Project Name : Land off Reeds Lane, Sayers Common

Job No : 22-258

Note Title : Flood Risk Assessment and Drainage Strategy Addendum No. 2

Date : 30 January 2026

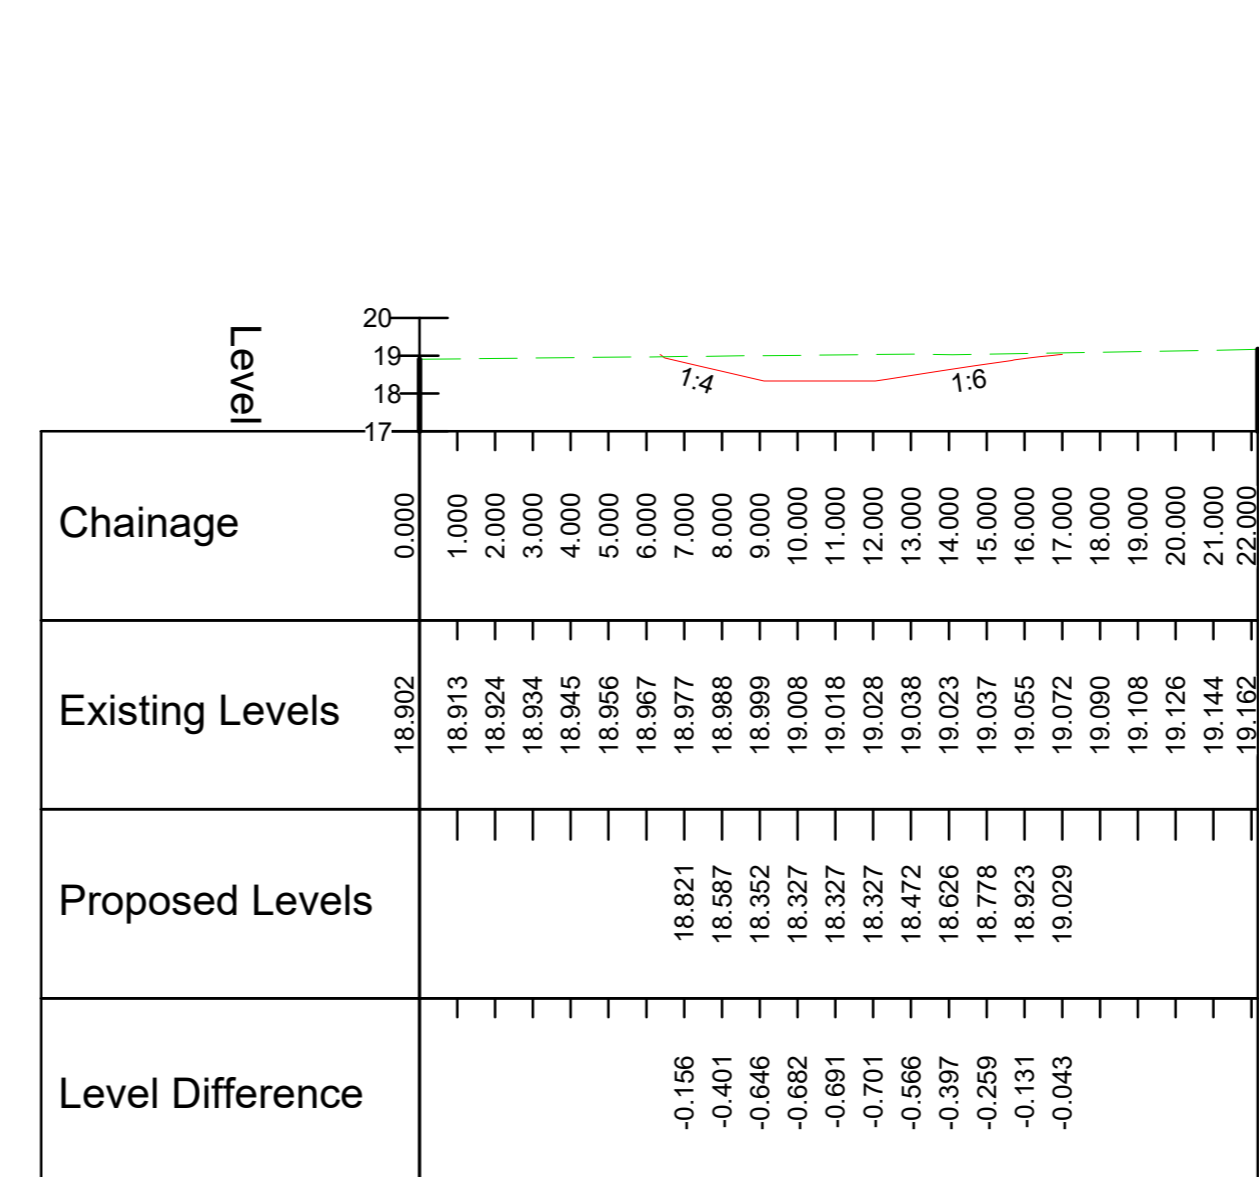
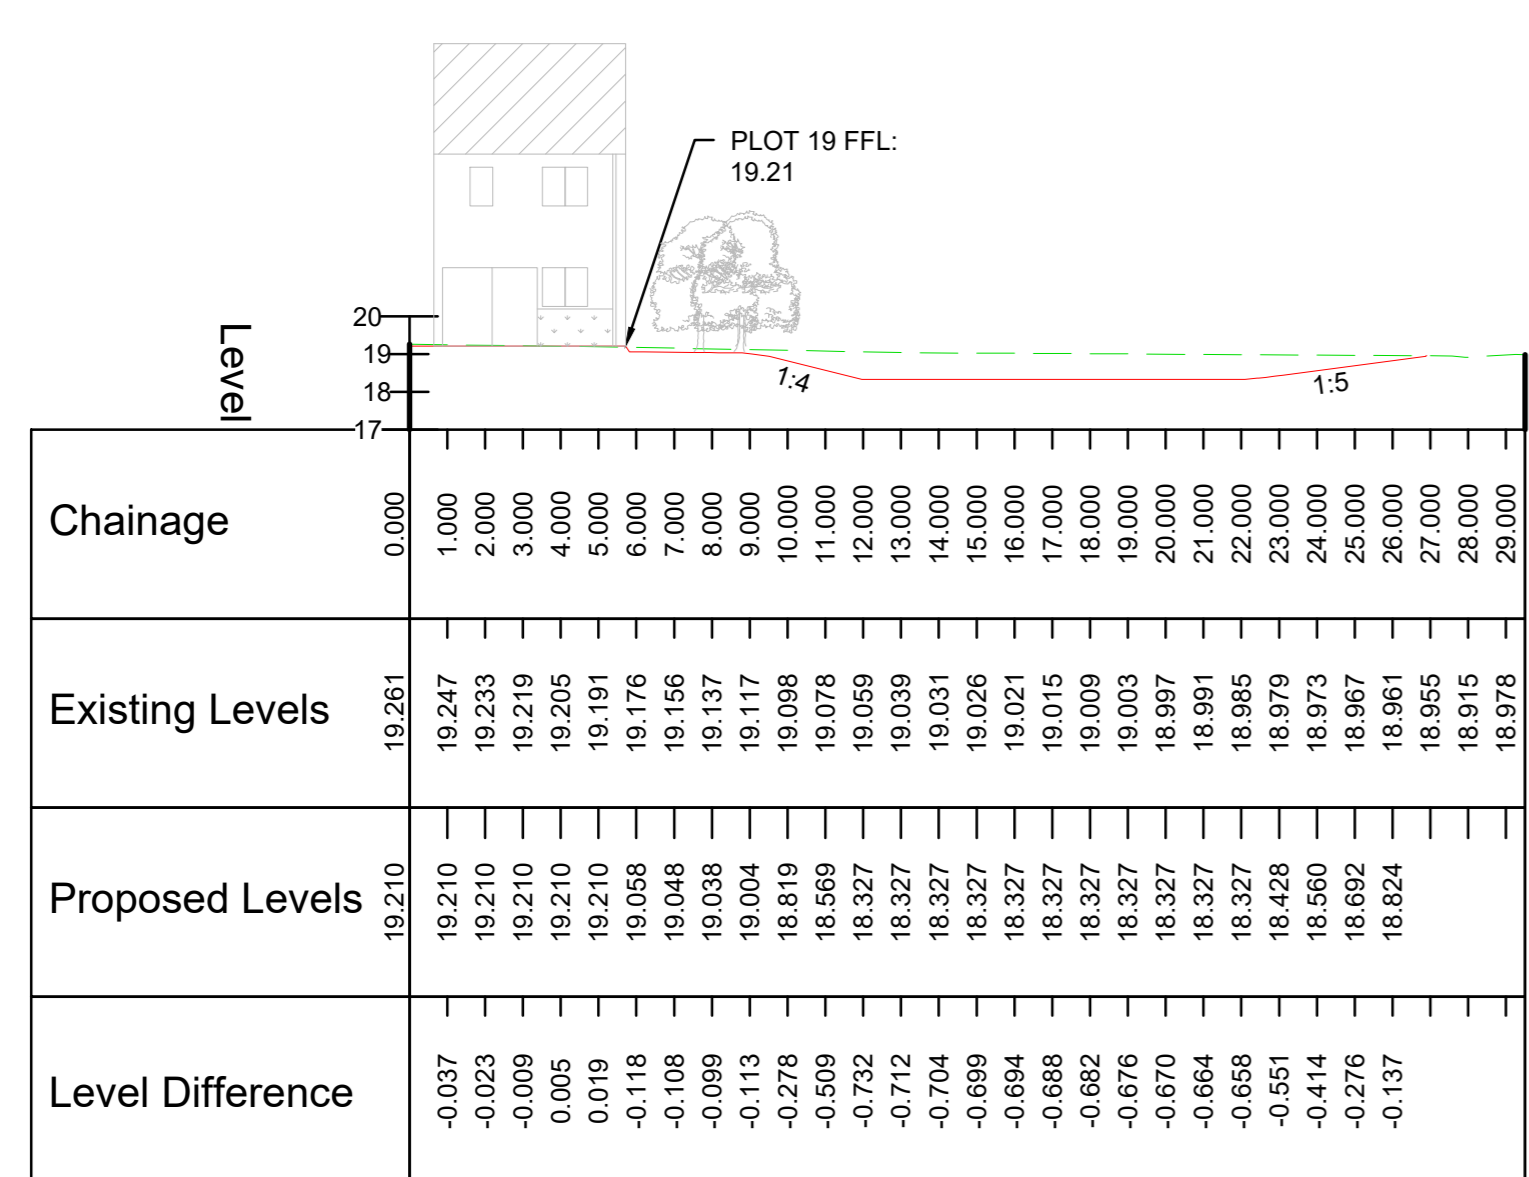
“On the drainage strategy there is no details about the basin included. Cross sections of the basin are also required. The basin should be designed following the SuDS Manual and any relevant sections of the National SuDS Standards.”

10. On the drainage strategy there is no details about the basin included. Cross sections of the basin are also required. The basin should be designed following the SuDS Manual and any relevant sections of the National SuDS Standards.

Unable to locate on portal.

2.1.3 The basin details are as follows:

- Plan area – 198.7m²
- Base area – 36.9m²
- Depth – 0.61m
- Slopes ranging from 1 in 4 slopes to 1 in 6 slopes. 1 in 4 slopes on the north and west sides, and 1 in 6 of the eastern side.

2.1.4 **Drawing 22-258-09** shows a plan and cross sections through the basins.

2.1.5 The basin would be designed following the SuDS Manual and National Standards for SuDS.
